Access Compliance Report

Public Rights-of-Way

Intersection ID: 10026412	Main Street: FARM_POND_LN	Cross Street: N/A	Location: SE
ADA ID: 8FB68594D5D1	Ramp Type: BlendTrans2	Initial Pass/Fail: Fail	Overall Compliance: No
		Severity Score: 12.5

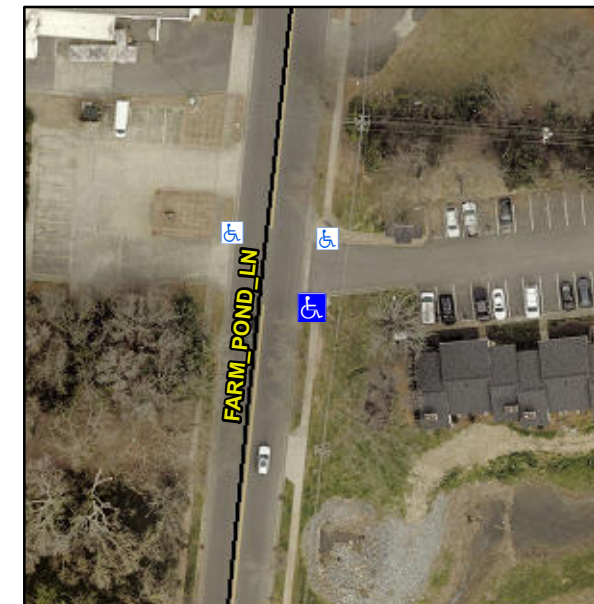
Not Found, R304.5.3

Compliance	Description	Data	Compliance	Description	Data
N/A	Ramp Length (in)	58.0	Yes	BlendTrans Slope (%)	1.9
Yes	Ramp Width (in)	48.0	No	BlendTrans XSlope (%)	6.7
N/A	Flare Type LT	N/A	N/A	Flare Type RT	N/A
N/A	Flare Slope LT (%)	N/A	N/A	Flare Slope RT (%)	N/A
N/A	Flare Traversable LT?	N/A	N/A	Flare Traversable RT?	N/A
N/A	Landing Length (in)	N/A	N/A	DWS Provided?	N/A
N/A	Landing Width (in)	N/A	N/A	DWS Contrast?	N/A
N/A	Landing Slope (%)	N/A	N/A	DWS Length (in)	N/A
N/A	Landing X Slope (%)	N/A	N/A	DWS Full Width?	N/A
N/A	Landing Curb? (Y/N)	N/A	N/A	DWS Offset (in)	N/A
N/A	Shared Landing?	N/A			
N/A	Gutter Ponding?	N/A	N/A	Gutter Slope (%)	N/A
N/A	Gutter Lip Ht (in)	N/A	N/A	Gutter X Slope (%)	N/A
N/A	Painted X Walk1?	No	N/A	Painted X Walk2?	No
	X Walk 1 Direction	To N		X Walk 2 Direction	To W
	X Walk 1 Width (in)	N/A		X Walk 2 Width (in)	N/A
	X Walk 1 Slope (%)	3.0		X Walk 2 Slope (%)	2.6
	X Walk 1 X Slope (%)	2.7		X Walk 2 X Slope (%)	3.8

N/A	Ramp inside XWalk1?	N/A	N/A	Ramp inside XWalk2?	N/A
	Road Slope (%)	3.3		Clear Space?	N/A
	Road X Slope (%)	2.5	N/A	Clear Space to XWalk (in)	N/A
N/A	Any Obstructions?	N/A	N/A	Storm Grate/Utility Hazard?	N/A
	Obstruction Type			Storm Grate/Utility Type	
		N/A			N/A
			Yes	Surface Condition? (G/P)	Good
			No	Curb Slope (%)	11.2

Remove & Replace Curb Ramp With Two New Directional Ramps or Equivalent.
